AS CONSTRUCTED SEPTEMBER

NOT FOR CONSTRUCTION

CITY OF SANDY
WASTE WATER TREATMENT FACILITY
IMPROVEMENTS
SECONDARY CLARIFIER
MECHANICAL PIPING PLAN

1 WASTE PUMP STATION PLAN
 M20 SCALE: 1" = 1'-0"

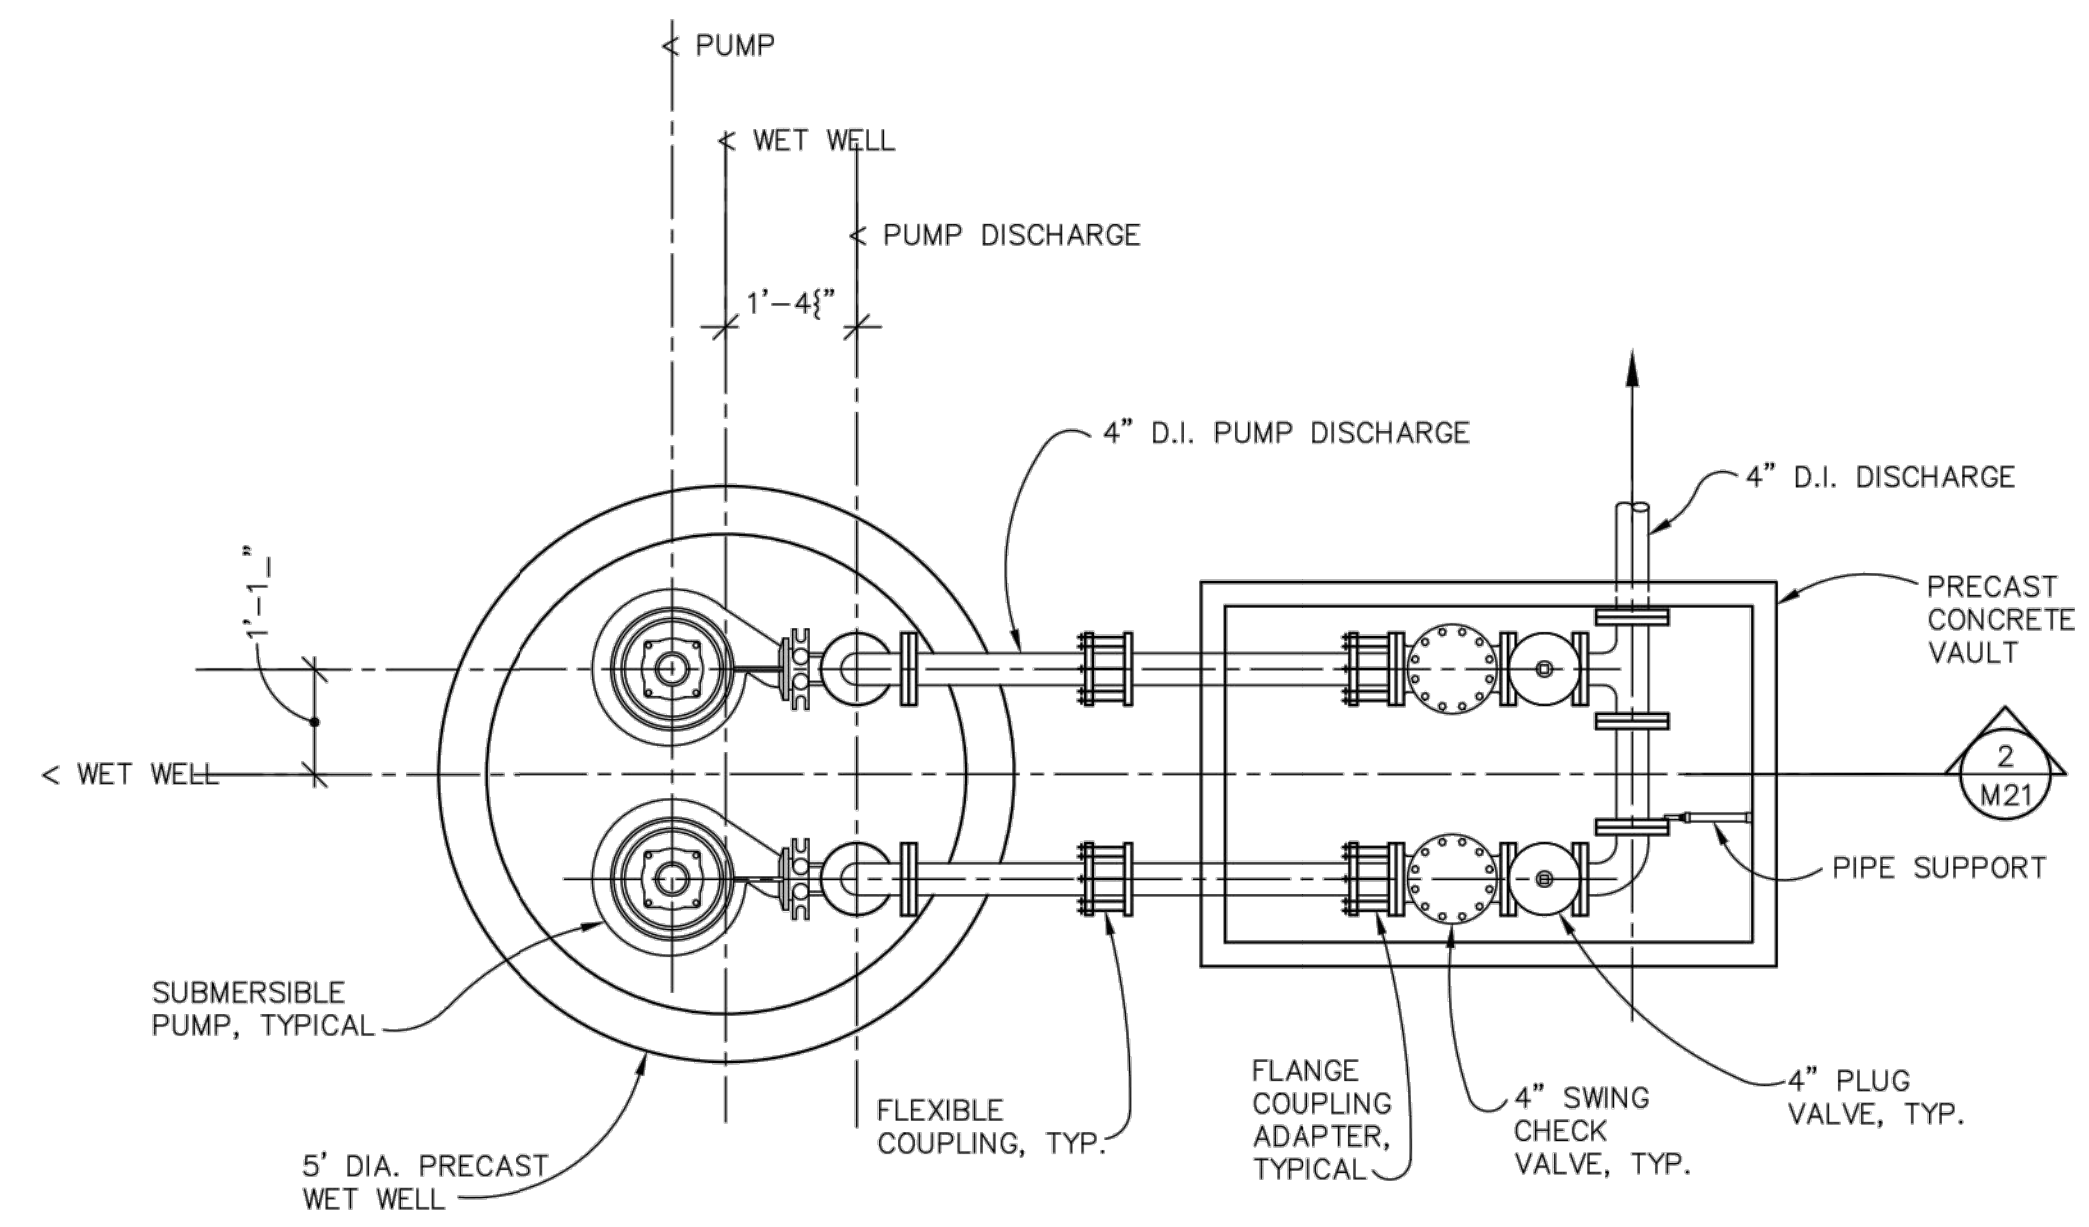
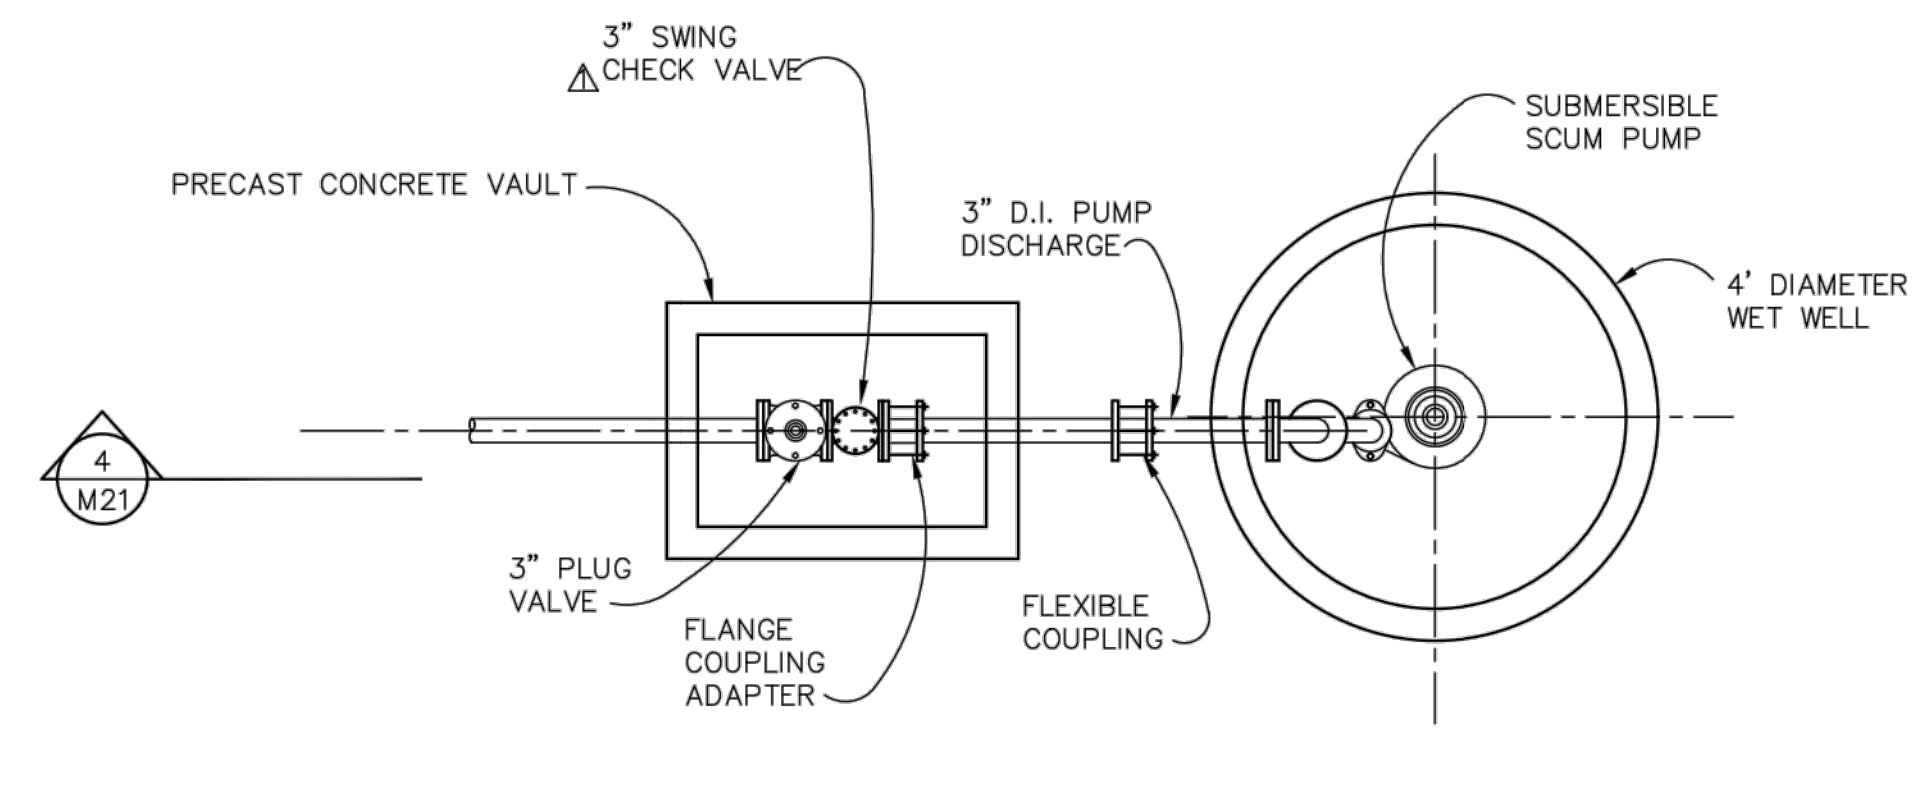
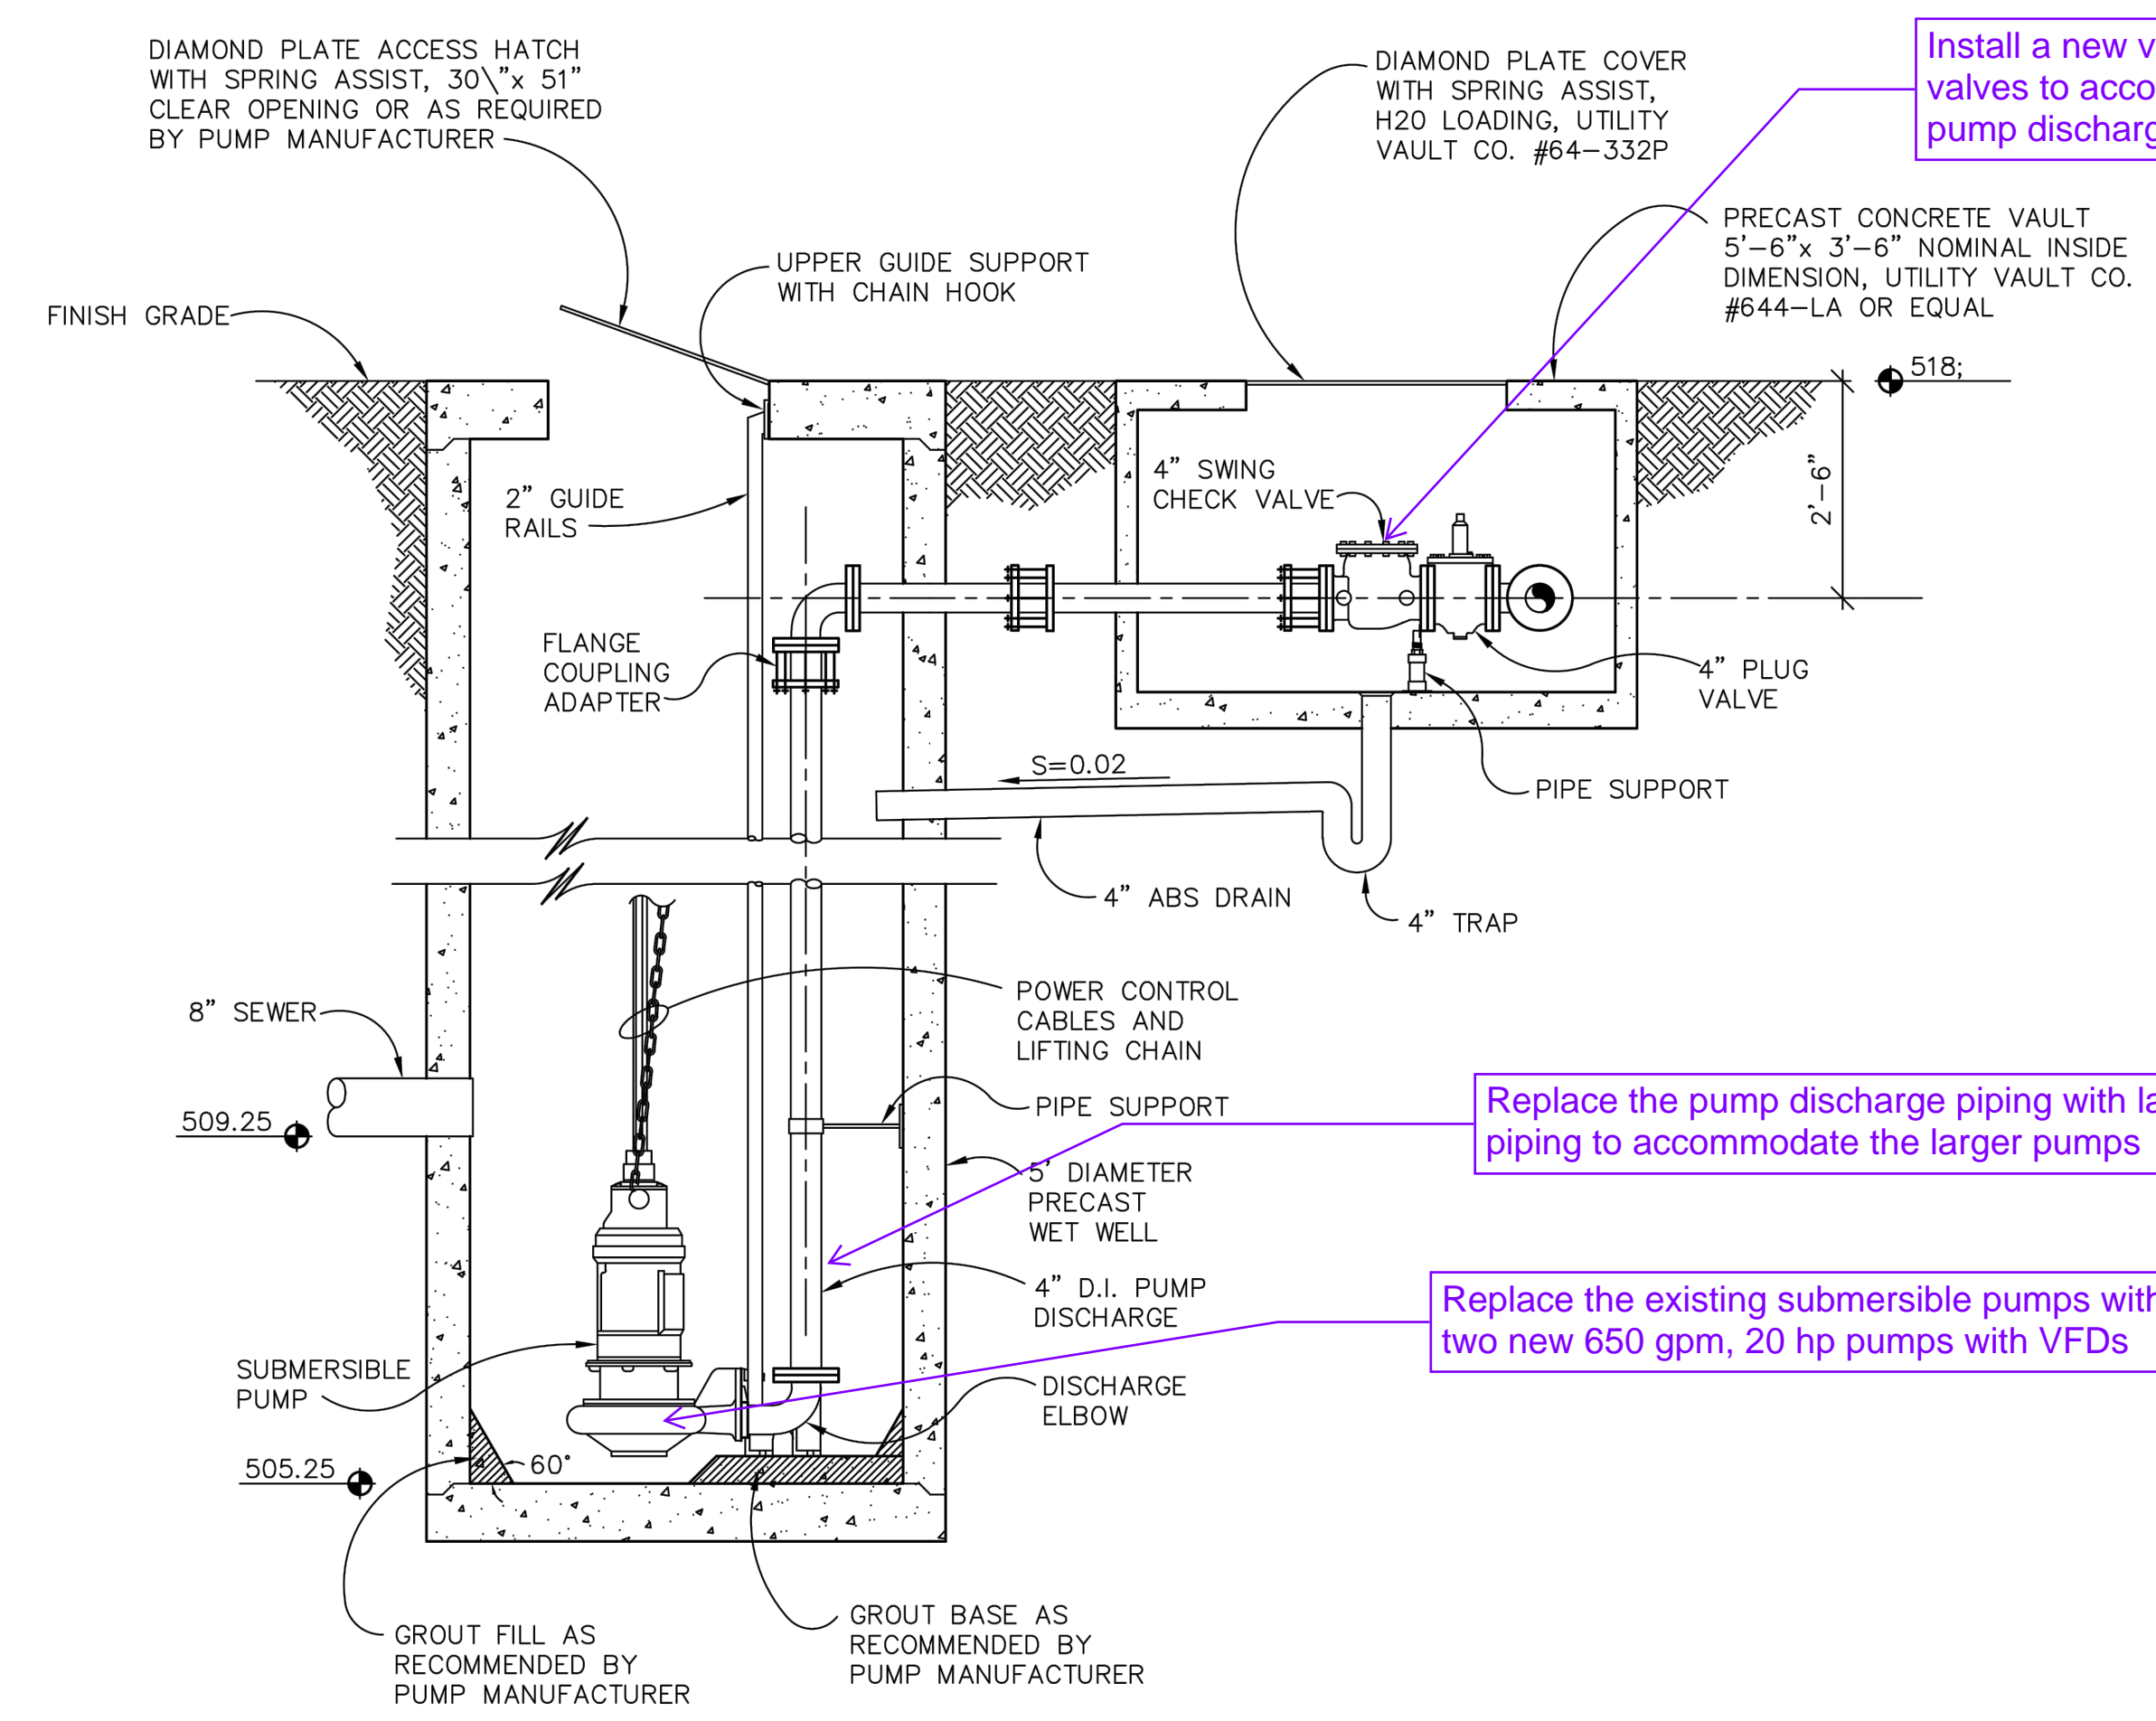
Install a new valve vault with new valves to accommodate the large pump discharge piping

Replace the pump discharge piping with larger piping to accommodate the larger pumps

Replace the existing submersible pumps with two new 650 gpm, 20 hp pumps with VFDs
